#24-142 RFP_BAFO - Daycare Expansion at Pavillon de la Jeunesse - CS Viamonde

ADDENDUM #2

Addendum 02

Project: CSV Pavillon de la Jeunesse Child Care Addition
105 High St, Hamilton, ON
Tender No.: 24-142

2 PARTIAL FIRST FLOOR POWER AND SYSTEMS PLAN
SCALE: 1:150

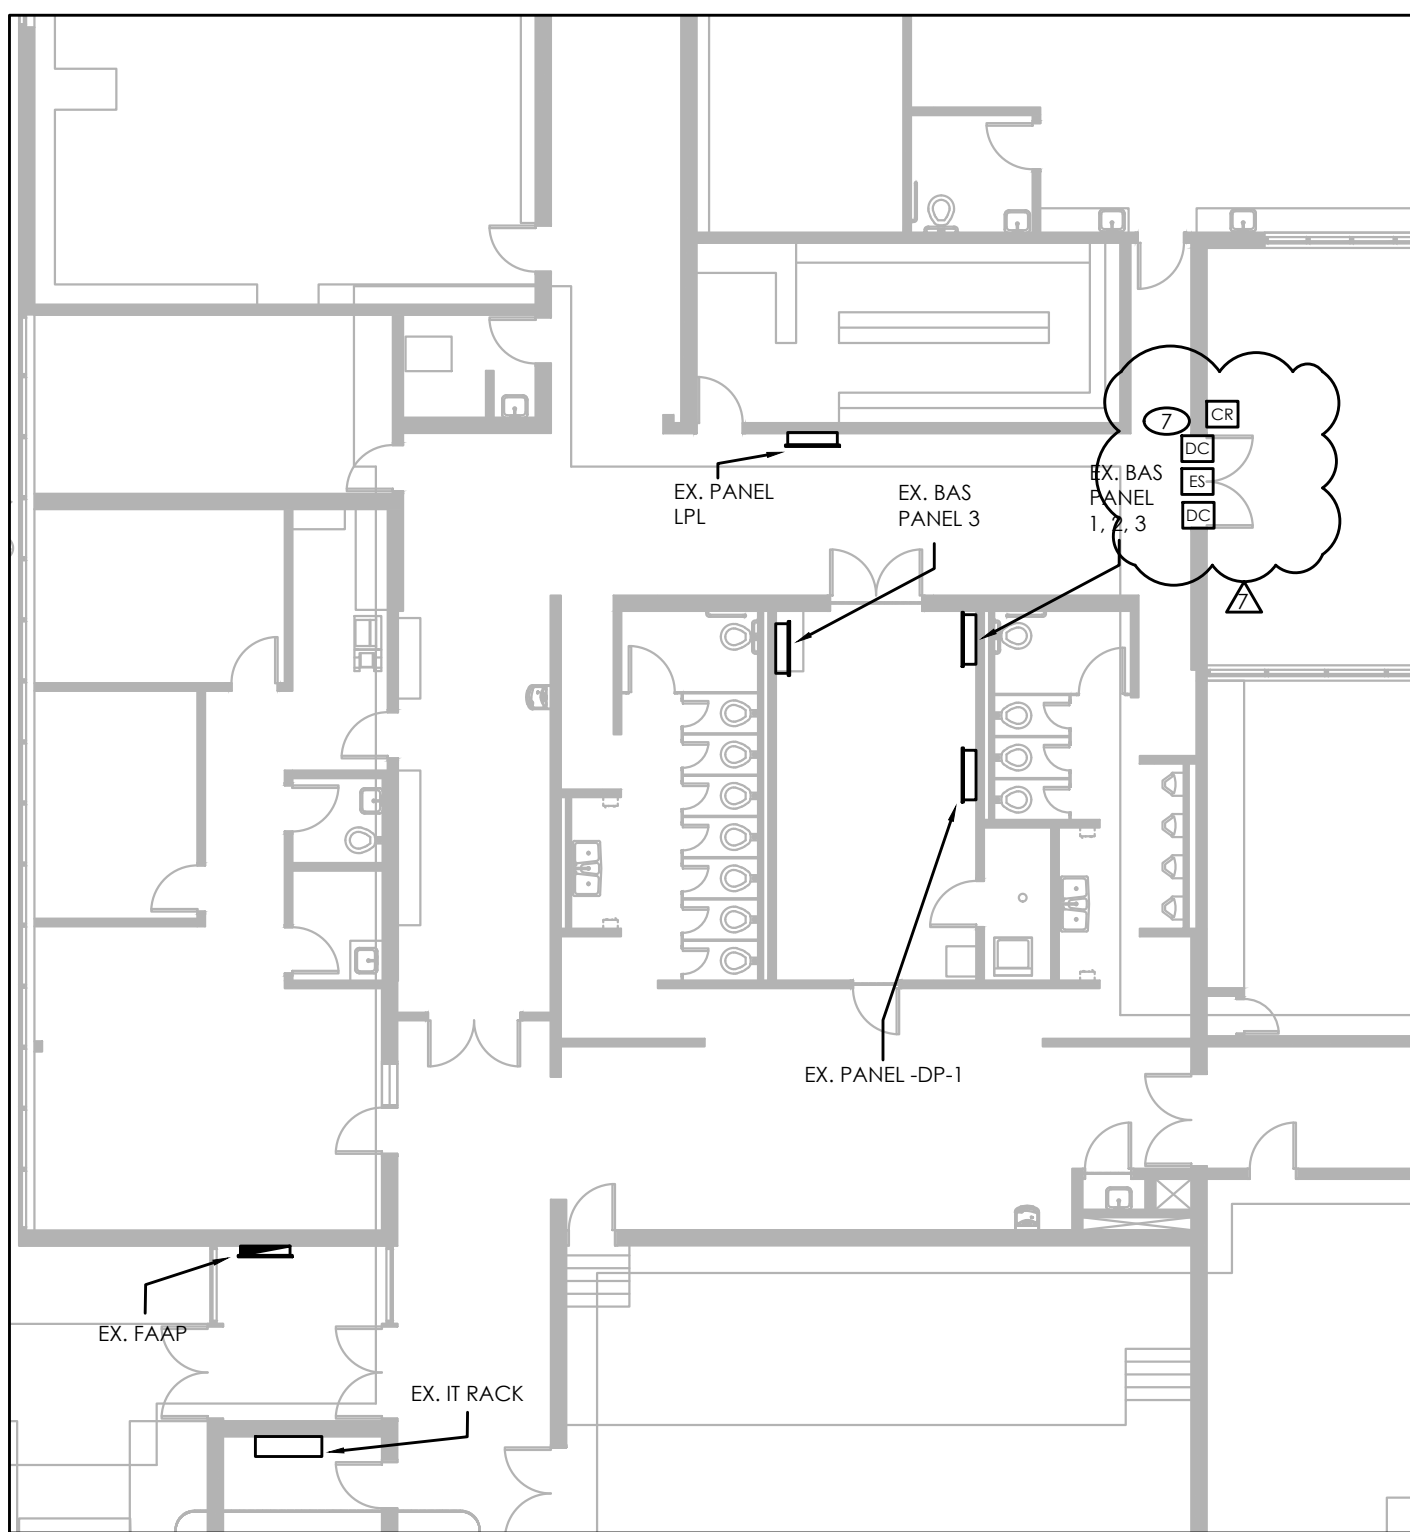
1.06	Question: D105A and D105B require ADOs as per the door schedule and hardware schedule but show nothing on the electrical power plan. Please confirm if these are required. Answer: Yes, power door operators are required at door D105A and D105B. Refer to Electrical Addendum E-02.

CLASSROOM CONTROL PANEL

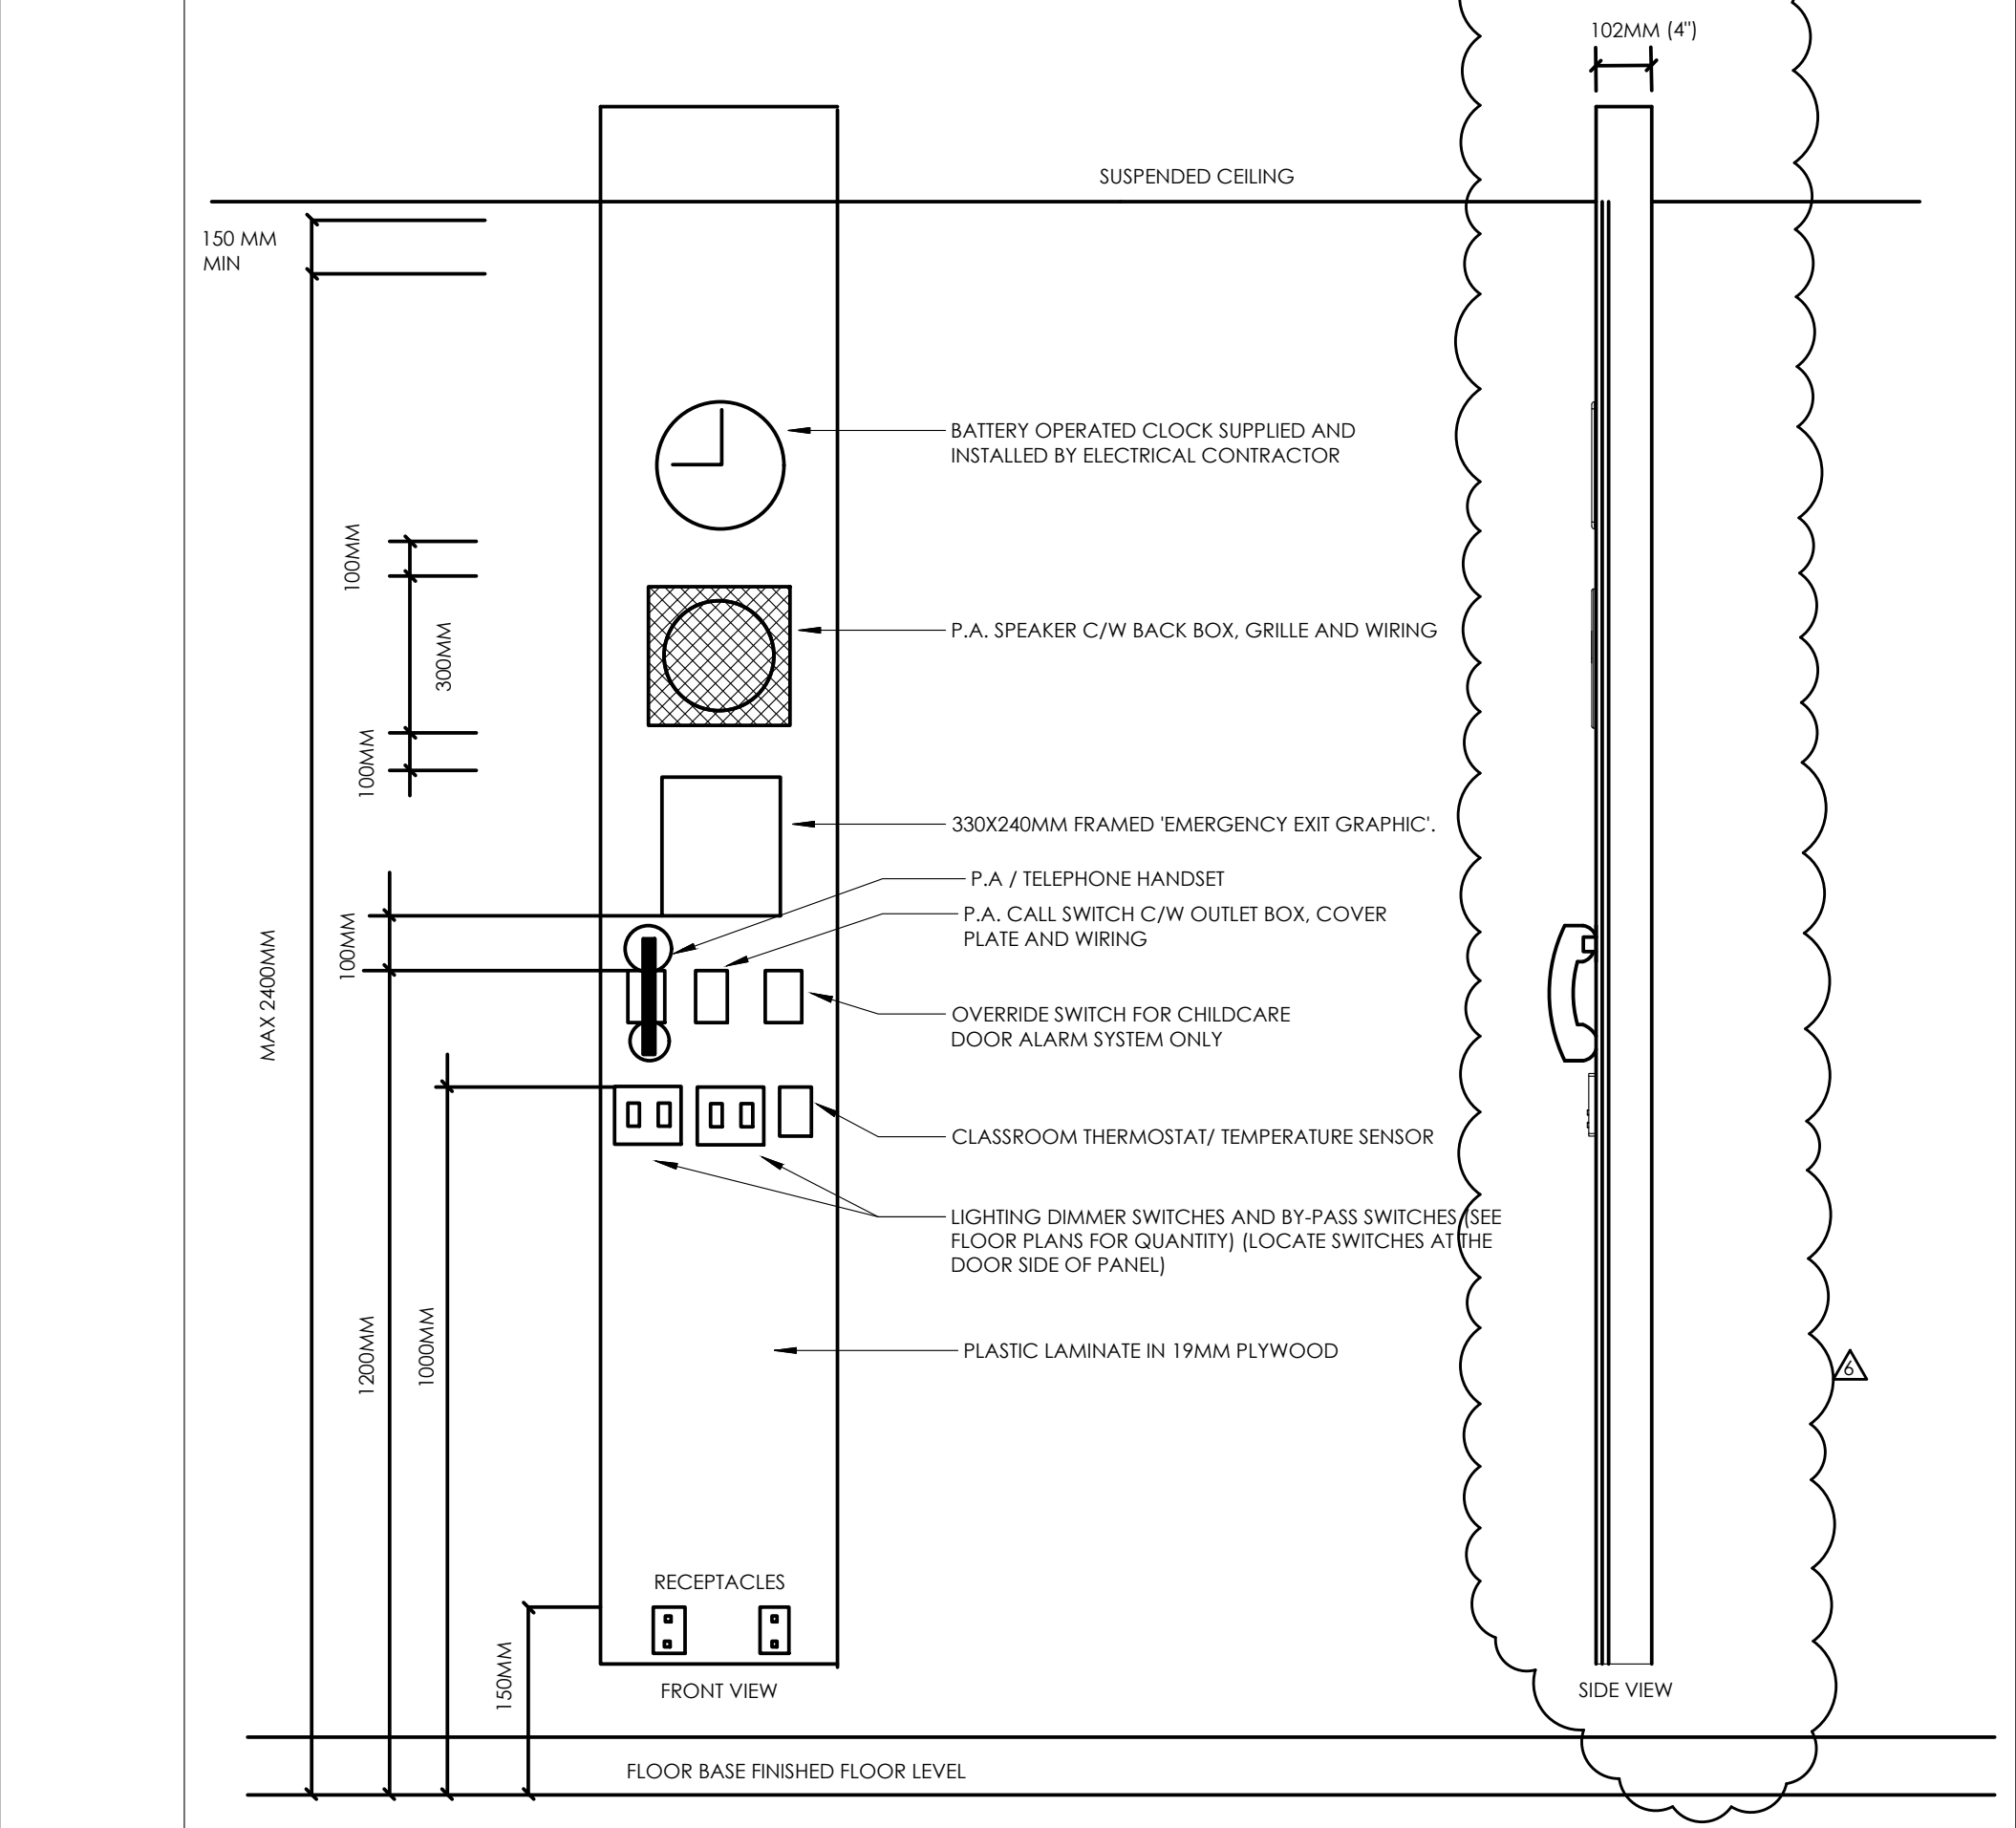
- .1 E0.1 Electrical Specifications
 - Updated specifications to include additional security information
- .2 E0.2 Electrical Specifications
 - Updated specifications to include additional security information
- .3 E1.0 First Floor Power and Lighting Demolition Plan
 - Updated scale in title block
- .4 E2.1 First Floor Proposed Power Plan
 - Added security hardware to door DS06
 - Added ADOs to doors D105A and D105B
 - Updated circuits to accommodate new ADOs
 - Updated scale in title block
- .5 E2.2 Existing Power Plan
 - Updated scale in title block
- .6 E4.0 Electrical Schedules
 - Updated ADO circuits
- .7 E5.0 Electrical Details
 - Added side view and depth to classroom control panel detail
